**Presentation to City of Seattle  
DESIGN REVIEW BOARD — EARLY DESIGN GUIDANCE**

DPD # 3010926

# 2030 8th Avenue

February 9, 2010

A-1 GRAPHICS FROM THE PREVIOUS EDG

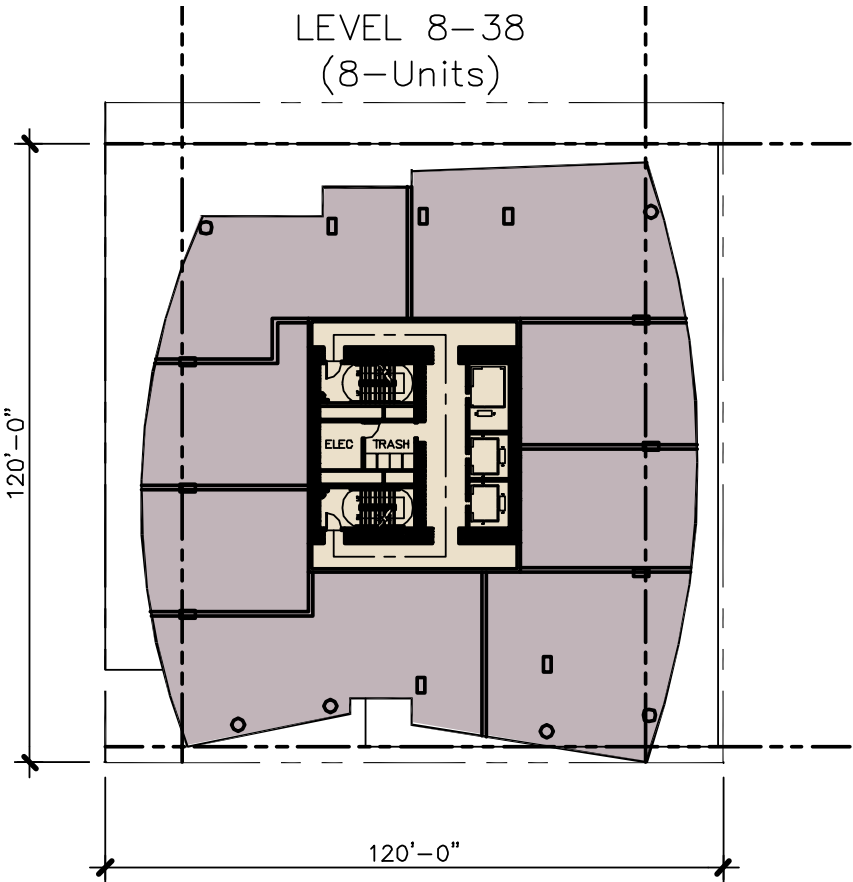
*The board ranked this as a high priority for the project due to the proximity of Westlake Ave, the Space Needle and the general development appearing in Denny Triangle. The board was interested in hearing from the architects in their presentation what anchors this building to Seattle in terms of design, architecture, materials or other features. The board also commended to development of a LEED building.*

*The board ranked this as a high priority for the project, in part due to its location and visibility as well as the proposal for a decorative/ornamental top. The board appreciated the attempts to give a subtle quality to the screening top.*

B-3

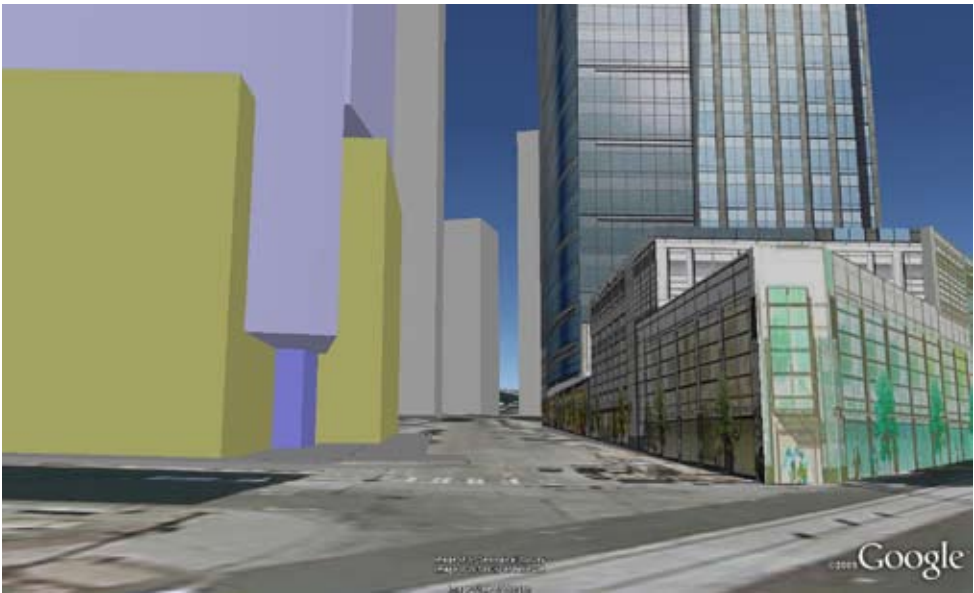
*The board gave a high priority to both B1 and B3, in part due to the opportunity to create a new context through developments like this in the Denny Triangle.*

B-4

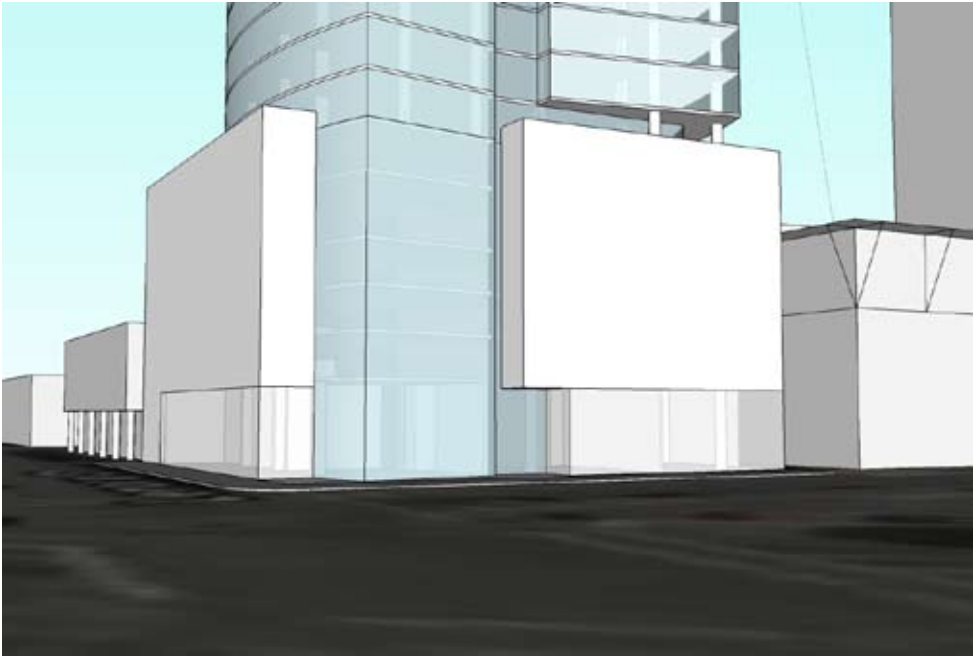
*The Board ranked this guideline as a high priority. The board felt it was important to continue development of this tower as a sleek and slender tower. The board also felt it was important to continue efforts to coordinate the transition between the base and the tower in a sensitive way as demonstrated in Option 3. The board expressed interest and support in locating the open space at the podium between the base and tower.*

**NEW CONSIDERATION:**  
*When organizing the interior and exterior spaces and developing the architectural elements, consider how the following can contribute to create a building that exhibits a coherent architectural concept: Building and Garage Entrances.*

C-4

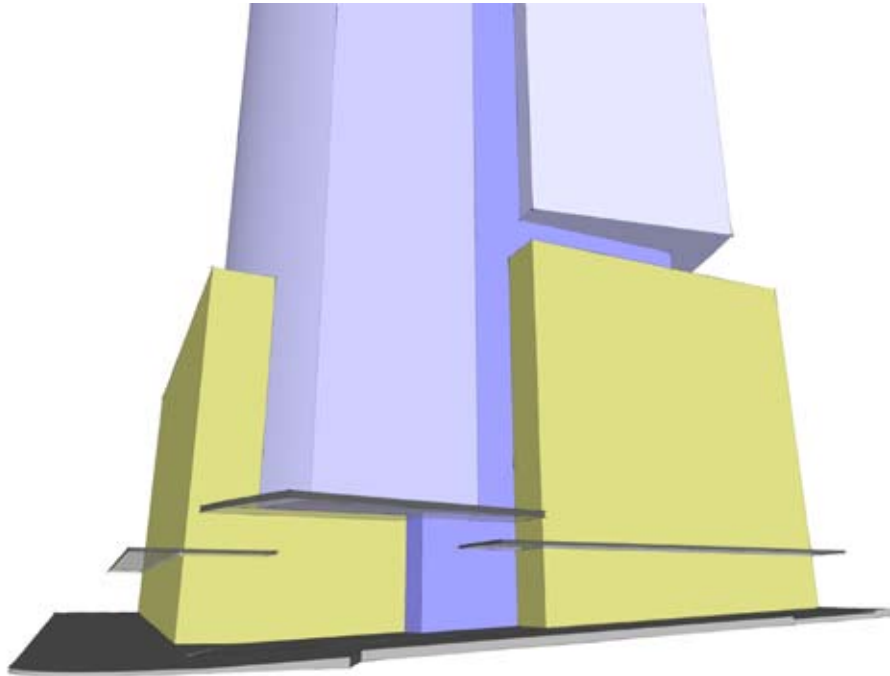
*The board prioritized these two guidelines due to the corner location of the building and the surrounding developments. The board is interested in continuing to look at the screening of the parking with uses and materials, how the entry ways for both the residential and retail uses are developed and how the south and east facades on the base structure are developed. The board also directed the applicant to look at how the design at the proposed stair tower on Option 3 at the NE corner at Lenora and the access easement will be enhanced.*

C-5

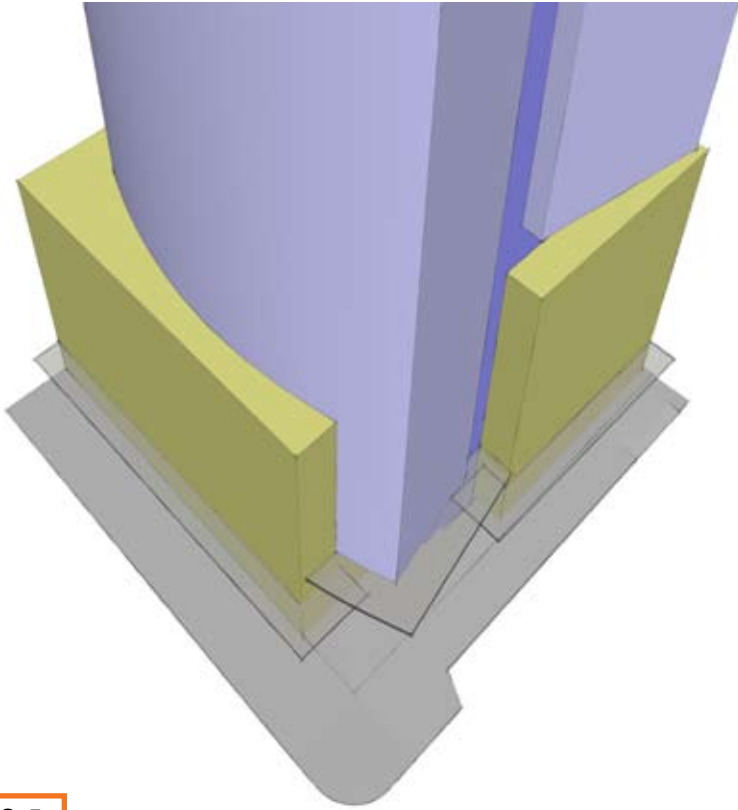
*The Board is interested in reviewing how the overhead weather protection on the building will be used to deal with the pedestrian scale along both 8th and Lenora.*

D-2

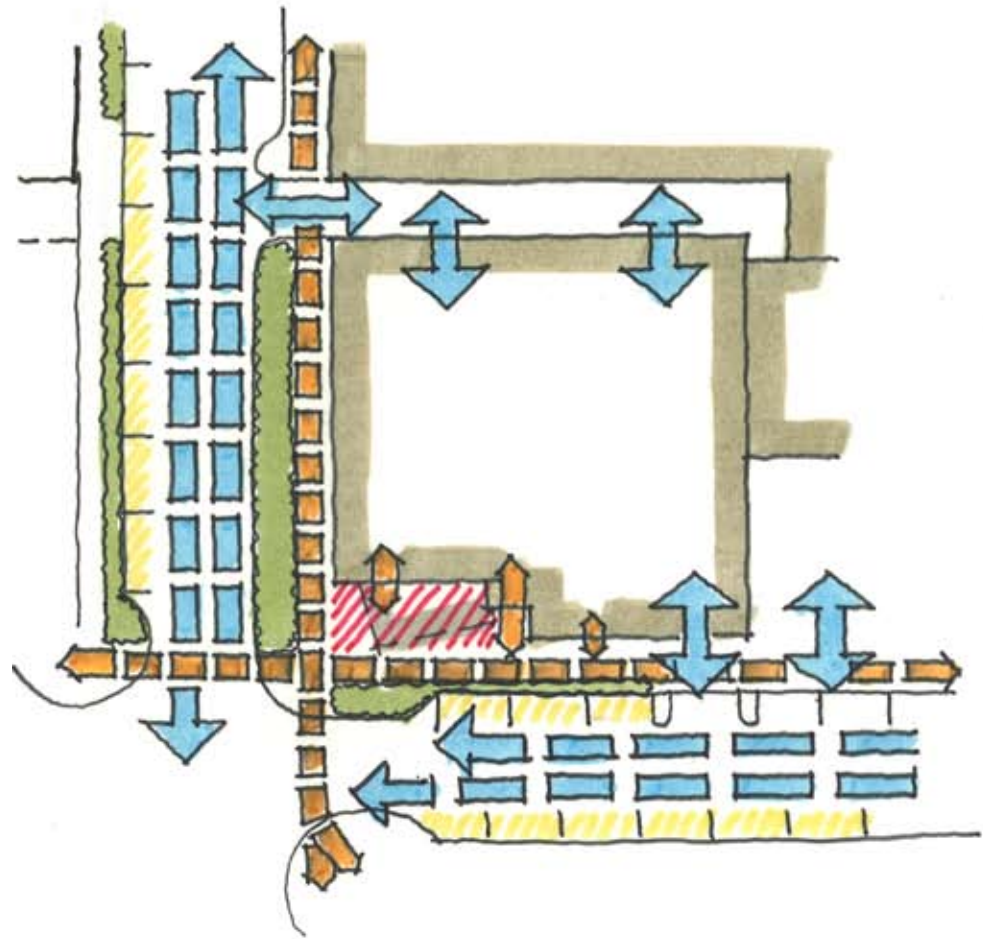
*The board ranked this as a high priority, in particular due to the Lenora Green Street. In addition, the board is interested in how landscaping at the street level as well a potential landscaping at the podium for the common recreation area, can be used to enhance the building facades.*

E-2

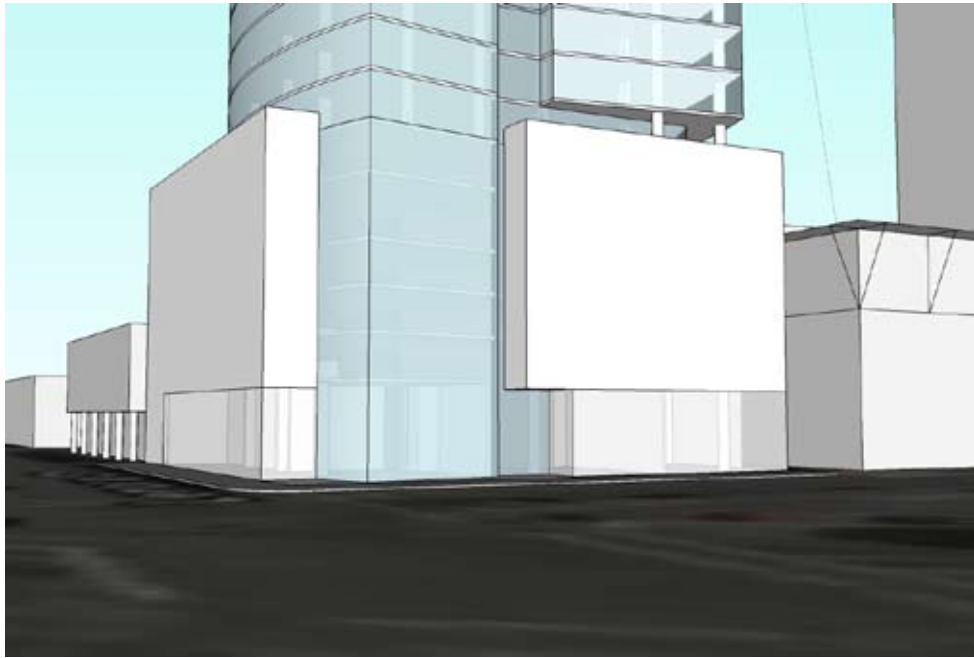
*The board prioritized this due to the visibility of the above ground garage structure in relationship to the base.*

**NEW CONSIDERATION:**  
**Minimize the visual impact of parking by integrating parking facilities with surrounding development. Incorporate architectural treatments or suitable landscaping to provide for the safety and comfort of people using the facility as well as those walking by.**
